Interim Update

Astley Business Park, Tyldesley, Wigan

Astley Warehouse Action Group

Document Ref.	Rev.	Date	Author
21184-TN-01	-	06 Aug 2026	Jamie Murray, MIOA, Director

Figure 1: Night-time L_{Amax} contours on the source data of the approved assessment (Scenario A)

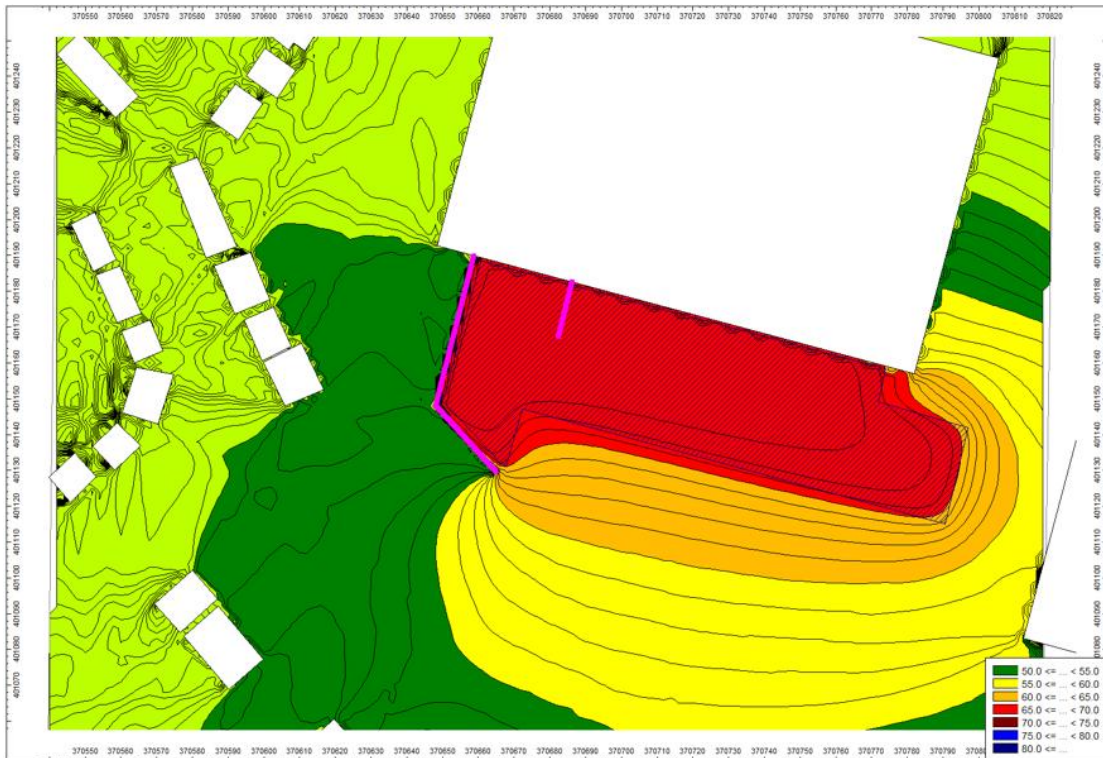
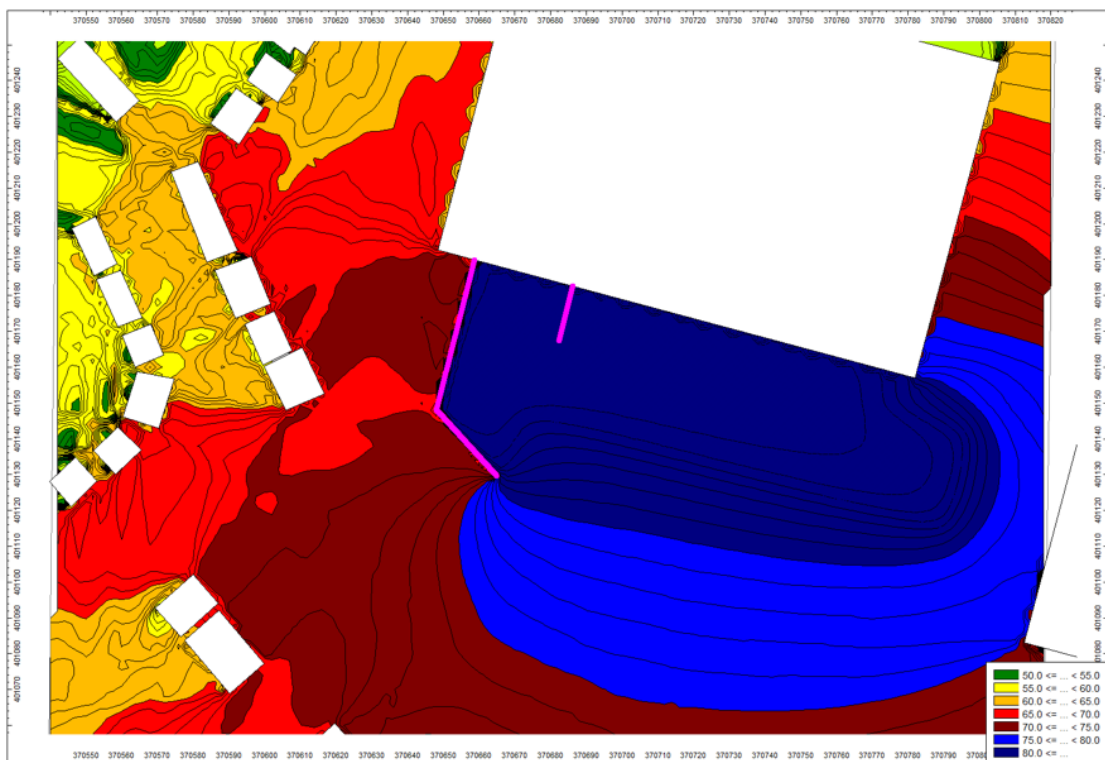
Scenario A applies the source data of the approved assessment. Scenario B applies source levels calibrated to reproduce the maximum levels measured at the survey position in July 2026. All other model inputs are identical between the two scenarios, such that the difference between Figures 1 and 2 is attributable solely to the source terms.

Scenario B gives a night-time maximum level of 71 dB L_{Amax} at the first-floor bedroom window position of receptor R05, against the 68 dB L_{AFmax} measured at 2.5 m at the survey position. The 3 dB difference reflects the reduced screening afforded by the boundary barrier at the greater receptor height.

Same model. Same houses. Same barriers.

The only thing that changed is how loud the site **actually** is.

Internally, against the 45 dB L_{Amax} criterion which the approved assessment adopted for itself, its predicted level of 36 dB compares with 61 dB derived from measurement. The contour comparison at Figures 1 and 2 indicates that the difference is not confined to that dwelling, and extends across the first row of properties on Withington Drive.

Figure 3: Internal night-time maximum levels at 38 Withington Drive against the adopted criterion

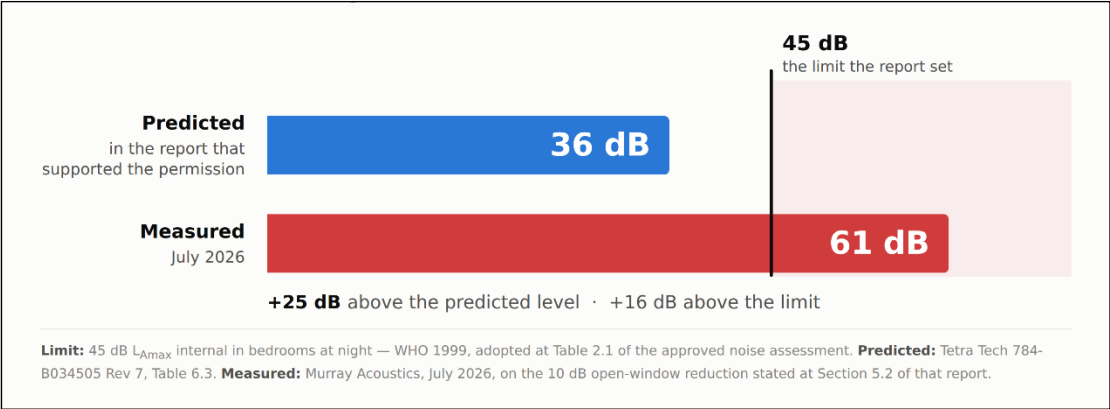
Figure 3 presents a comparison of the levels derived from measurement at the worst affected dwelling against the corresponding predictions of the approved assessment, at the same receptor position and height. Internal levels are derived using the open-window reductions given in the approved assessment itself.

61 dB in a bedroom at night.
Likely to be perceived as **five times as loud as predicted**
during the planning process.

The predicted internal level applies the 15 dB reduction used in the report's assessment tables; the measured internal level applies the 10 dB reduction stated in its method. On a consistent 15 dB basis the measured internal level is 56 dB, and the difference 20 dB.

The levels derived from measurement are approximately 20 dB above the predicted external level, and 25 dB above the internal level predicted for this dwelling in the approved assessment. The decibel scale is logarithmic, and an increase of 10 dB is generally perceived as a doubling of loudness, such that a difference of this order represents individual events of the order of more than four to five times as loud as those predicted.
